Response to Draft Report and Decision for Turitea Wind Farm Huatau Marae (Submitter No. 9)

**Huatau Marae Submission in Response to the Draft Report and
Decision of the Board of Inquiry into the Turitea Wind Farm
Proposal dated 11 February 2011**

Plate T1: Proposed Turitea Wind Farm Noise Levels in Relation to residences and other receivers

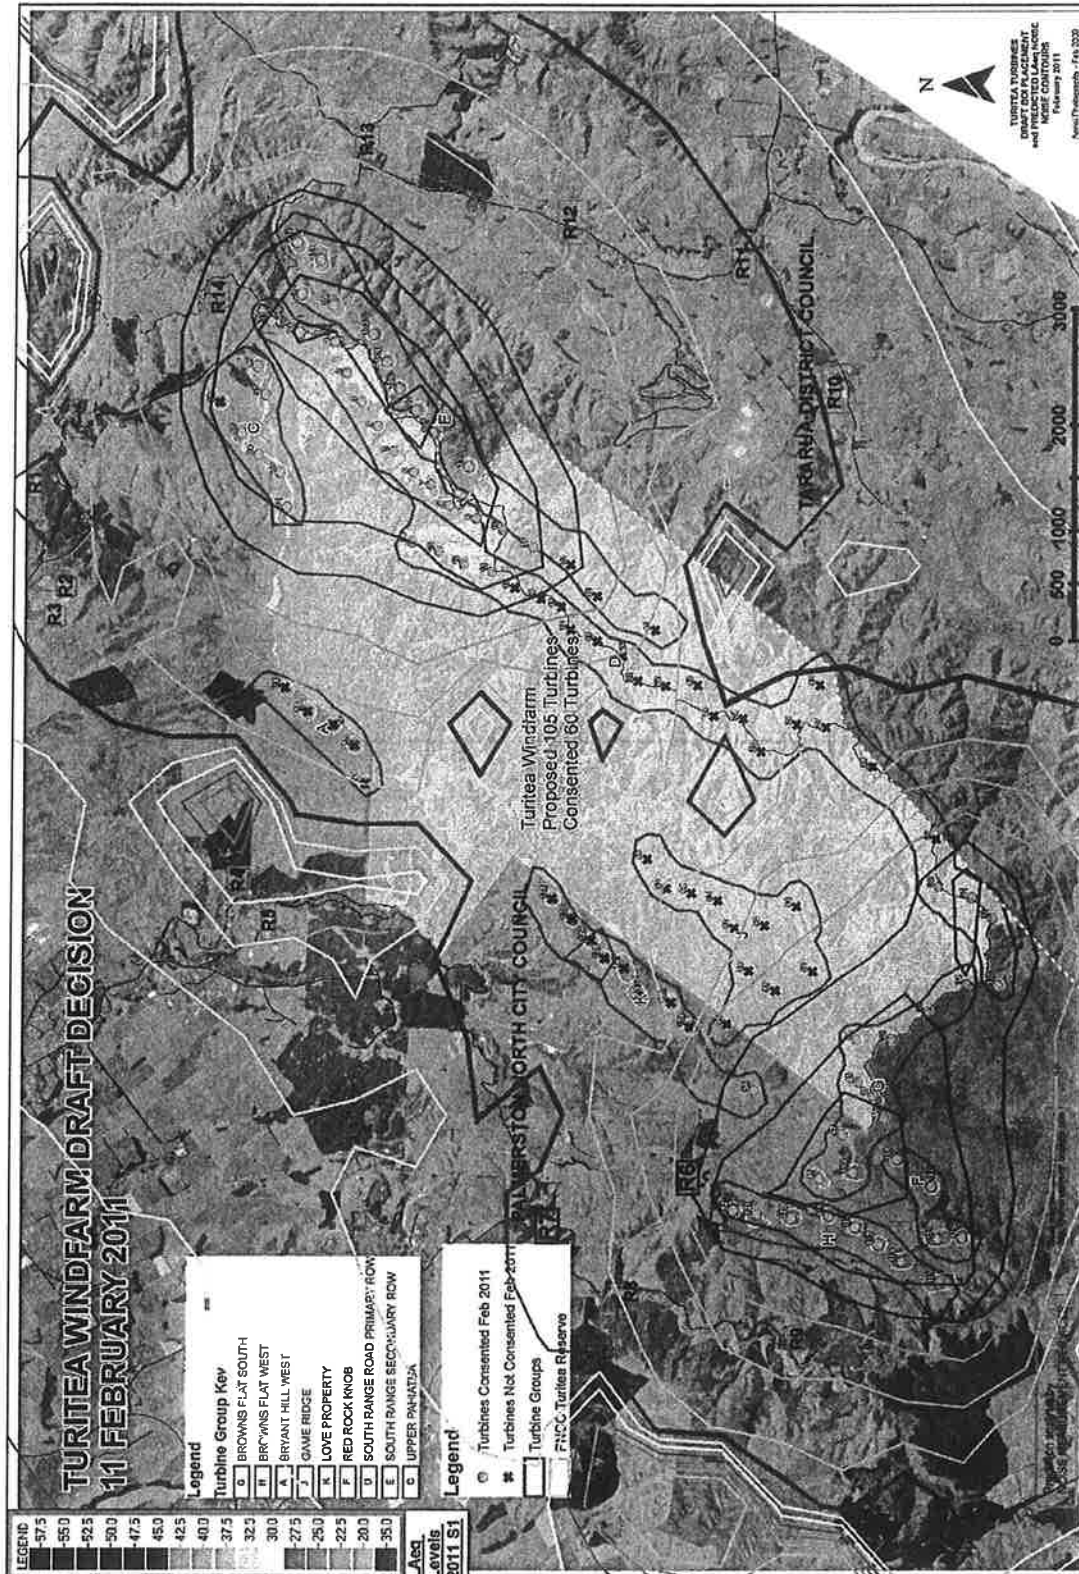
3.6 The predictions, made under ISO 9613-2 as required by NZS6808:2010. Some residences are significantly affected and will be above the criteria established by the Inquiry. There will be significant variation under south-east wind conditions. This is of particular importance for your home and Huatau marae (and residences to the north and north-west of the wind farm) as these are downwind of rows of turbines. Increases in sound level of 3dB to 6dB as well as significant amplitude modulated audible characteristics are anticipated. The penalty of 5dB for special audible characteristics must therefore be considered.

3.7 ISO 9613-2, as applied by the 2010 wind farm standard, states that the estimated accuracy for broadband noise under the meteorological conditions allowed for (a wind speed of between 1m/s and 5m/s at a measurement height of 3m to 11m above the ground) is an uncertainty of ± 3 dB. Thus it can be argued that by definition the standard does not apply to the high-wind conditions that are experienced at wind farms and the standard cannot be termed 'conservative'. That aside, in order to comply with the standard the range of predicted average levels must be considered, Table 2.

Plate T1: Proposed Turitea Wind Farm Noise Levels in Relation to residences and other receivers

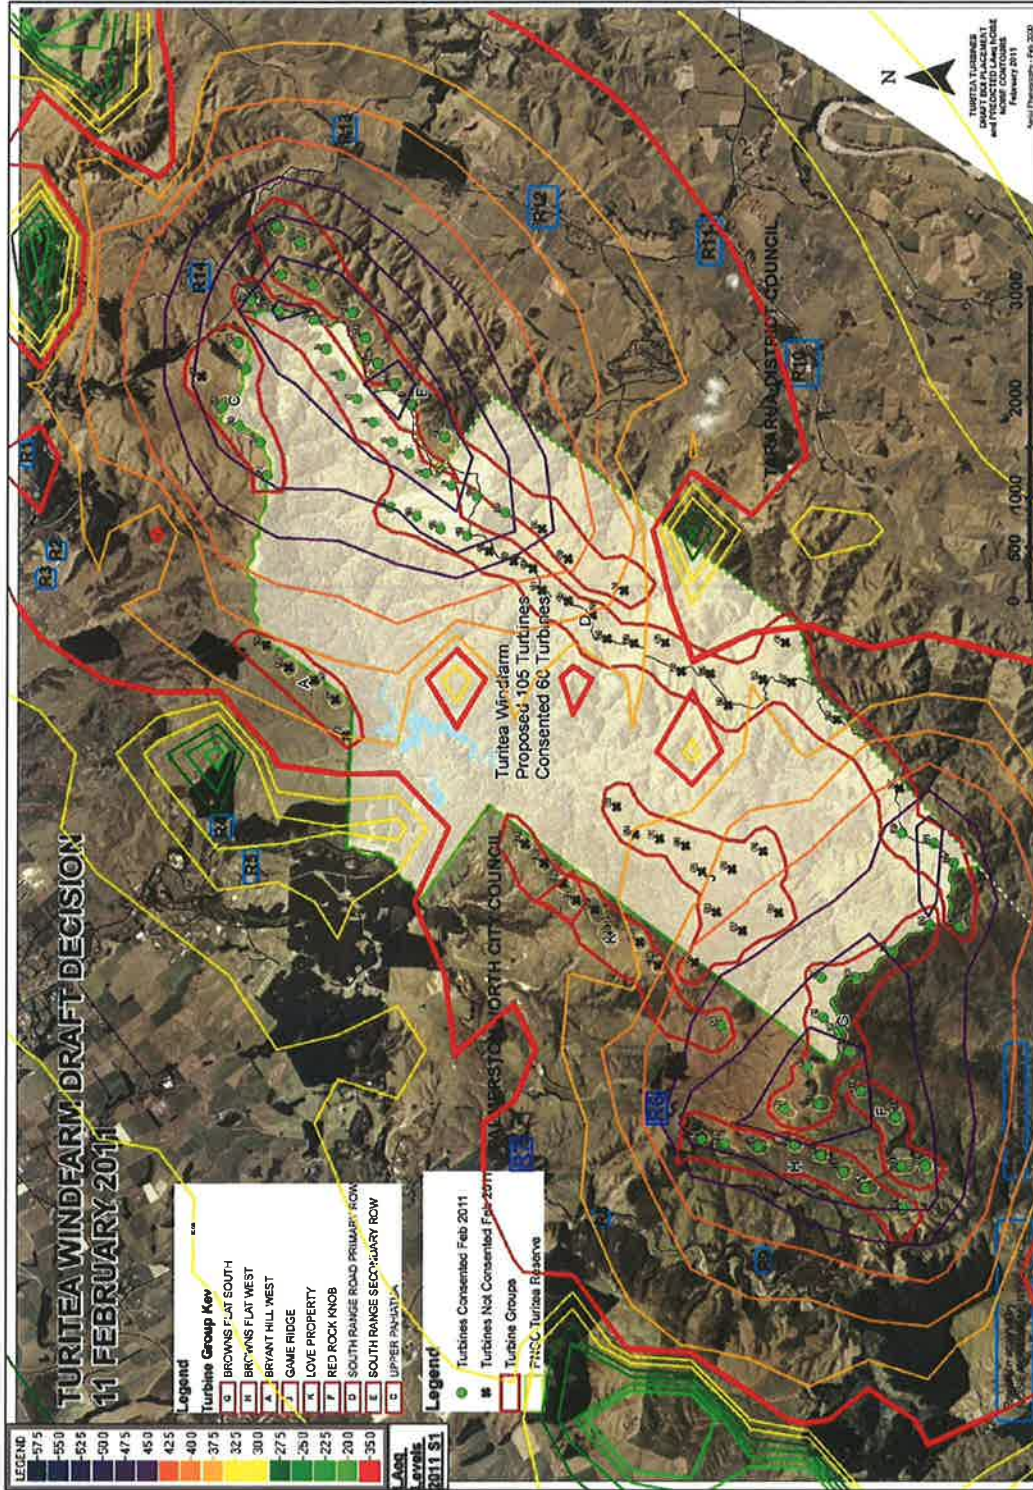
3.6 The predictions, made under ISO 9613-2 as required by NZS6808:2010. Some residences are significantly affected and will be above the criteria established by the Inquiry. There will be significant variation under south-east wind conditions. This is of particular importance for your home and Huatau marae (and residences to the north and north-west of the wind farm) as these are downwind of rows of turbines. Increases in sound level of 3dB to 6dB as well as significant amplitude modulated audible characteristics are anticipated. The penalty of 5dB for special audible characteristics must therefore be considered.

3.7 ISO 9613-2, as applied by the 2010 wind farm standard, states that the estimated accuracy for broadband noise under the meteorological conditions allowed for (a wind speed of between 1m/s and 5m/s at a measurement height of 3m to 11m above the ground) is an uncertainty of ± 3 dB. Thus it can be argued that by definition the standard does not apply to the high-wind conditions that are experienced at wind farms and the standard cannot be termed 'conservative'. That aside, in order to comply with the standard the range of predicted average levels must be considered, Table 2.
